**STATE OF IOWA
BEFORE THE IOWA UTILITIES BOARD**

IN RE:)	
)	
INTERSTATE POWER AND LIGHT COMPANY and PRESTON MUNICIPAL UTILITIES)	DOCKET NO. SPU-2021-0015
)

JOINT RESPONSE TO BOARD STAFF CORRESPONDENCE

Zoomed area to be exchanged identified in the shapefile sent to the IUB.
(Identified as Areas #1, #2 and #3 in IUB's "Attachment A")

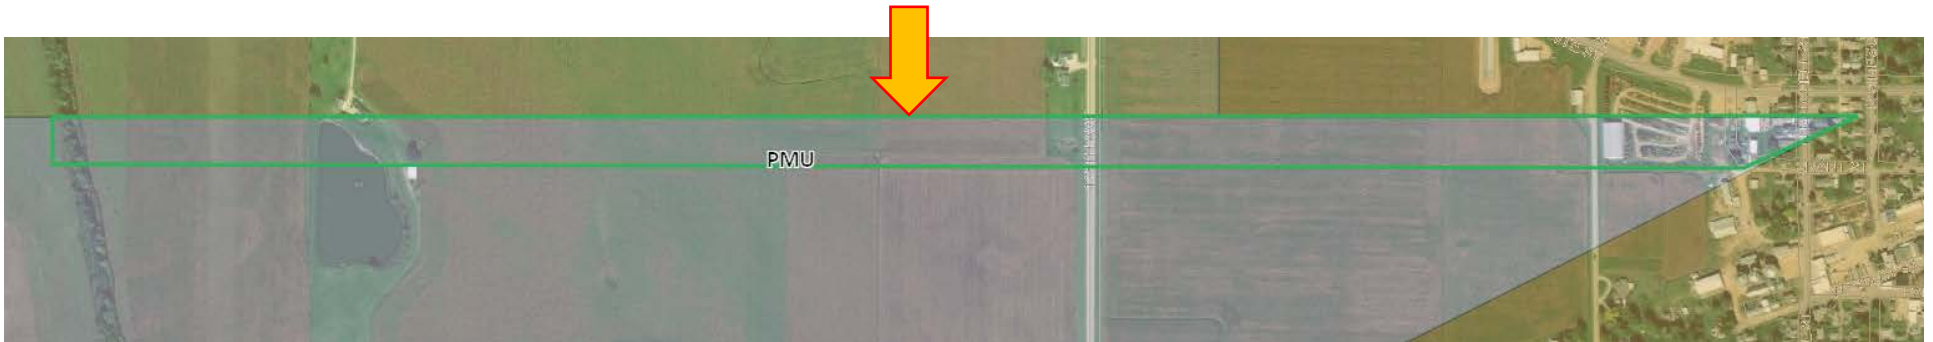
As proposed in the Petition and supporting documents, IPL and PMU mutually agree that PMU will serve the area marked by the dashed pink boundary line. The map shows that PMU (tan color) is already serving a portion of the service area proposed to be modified.

Explain this data discrepancy. Specifically, do the parties agree with the modification as proposed in Attachment A? If not, provide an explanation to the contrary.

As proposed in the Petition and supporting documents, IPL and PMU mutually agree that IPL will serve the area marked by the dashed red boundary line. The map shows that IPL (lavender color) is already serving the area proposed to be modified.

Explain this data discrepancy. Specifically, do the parties agree with the modification as proposed in Attachment A? If not, provide an explanation to the contrary.

IPL and PMU filed a PDF aerial map labeled "Interstate Power and Light Company and Preston Municipal Utilities Electric Service Territory Realignment." This map shows elongated polygons that weren't identified by legal description/parcel information in the Petition or supporting documents.

Provide an explanation of this identified area. If the area identified is a proposed modification, provide the legal description/parcel information.

IPL suggests that the shapefile aeriels IPL submitted in this filing supersede the additional exhibits which were included for detail, for IUB mapping. Specifically, Area #1 identified in the Attachment A from the Board, should not include the area in tan color (PMU territory) but only reflect the IPL territory within the pink dashed polygon. See Attachment 1 to this document.

The Board is correct, the parties agree with the proposed modification as plotted in the Board's Attachment A, reflected by the dashed red polygon. At the time the shapefile that was submitted was created, Area #3 was in PMU territory. IPL added the Board's new web map as a layer in its GIS application and it feeds live into IPL's GIS application. See Attachment 1 to this document for detail of the electric service territory when the shapefile was created.

It is not IPL's intention to include these elongated polygons in this filing as areas that are to be exchanged. IPL was identifying areas where the new online GIS map does not match up to the official color PDF Electric Service Territory Map. (Please see Attachment 1 to this document). Because the official color PDF Electric Service Territory Map is the official source and correctly depicts the service boundaries, no modification is needed. However, the online GIS map will need to be adjusted to accurately reflect the official territory boundaries. Preston Municipal Utilities (PMU) has authorized IPL to represent that PMU does not object to this description of the situation.

The shapefile should supersede the original aerals. The original aerals are included to offer detail for IUB mapping and were the initial Exhibits when this filing was initially drafted back in 2017.

Elongated Areas identify where the new Board Web Map does not agree with the previous paper PDF color Electric Service Territory Maps.

These areas are not a part of this filing but were an attempt to make the IUB aware of the difference in the two maps.
